DEPARTMENT OF THE ARMY
SEATTLE DISTRICT, CORPS OF ENGINEERS
P.O. BOX 3755
SEATTLE, WASHINGTON 98124-3755

Please reference Request for Proposals (RFP) No. DACA67-03-T-2002, entitled Renovate
Buildings 1170, 1205, and 1207 at McChord Air Force Base available for downloading from the
following website:
<http://www.nws.usace.army.mil/ct/ebs/ViewprivateSolicitation.asp?SolicitationNumber=DACA67-03-T-2002>.

This letter constitutes amendment R0003 to the solicitation dated 23 July 2003. This
amendment incorporates the following revisions:

SHEET NO.
A19/SD-1

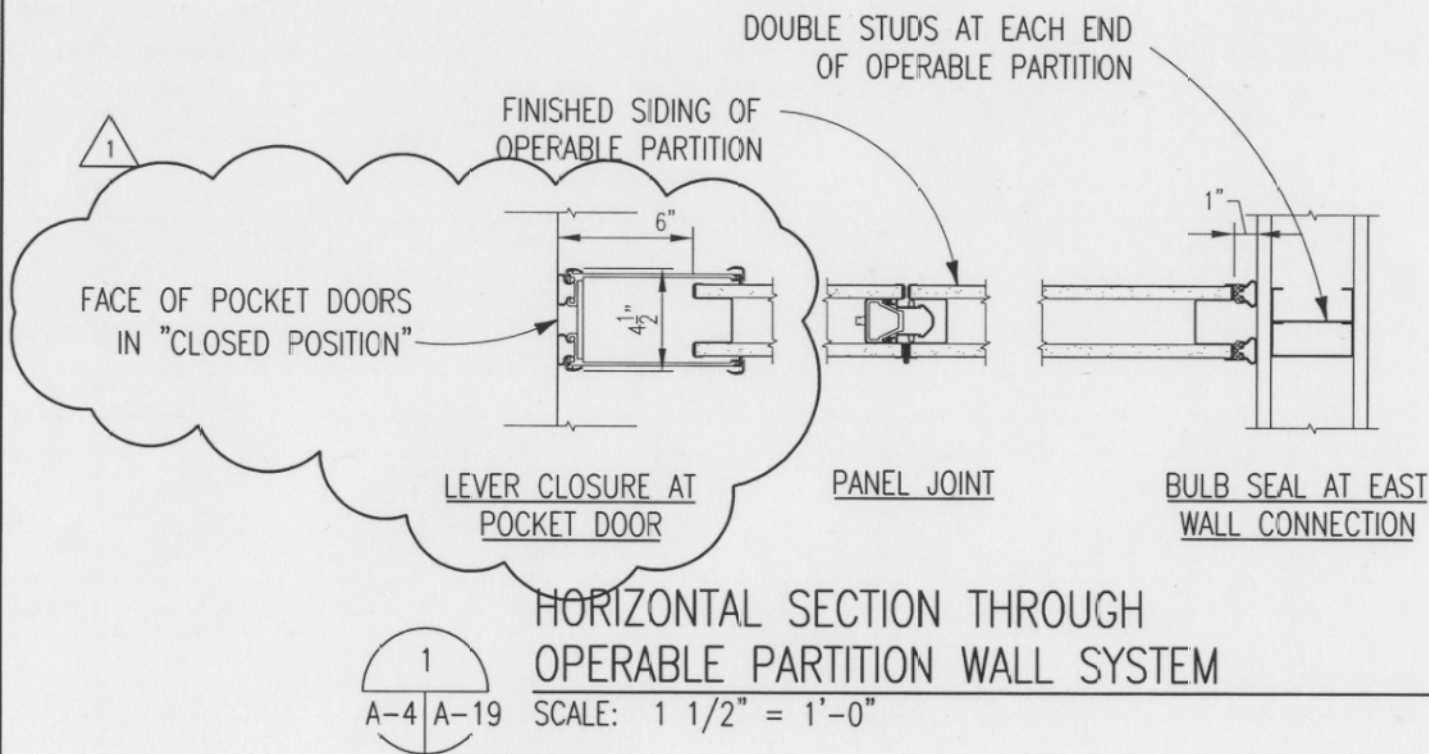
Plate A-19: Revise Detail 1/A4/A19 as shown on Sketch A19/SD-1 attached at the end of this Section.

REVISIONS	DATE	DESCRIPTION
1	8-11-03	REPLACE DETAIL 1-A/A19
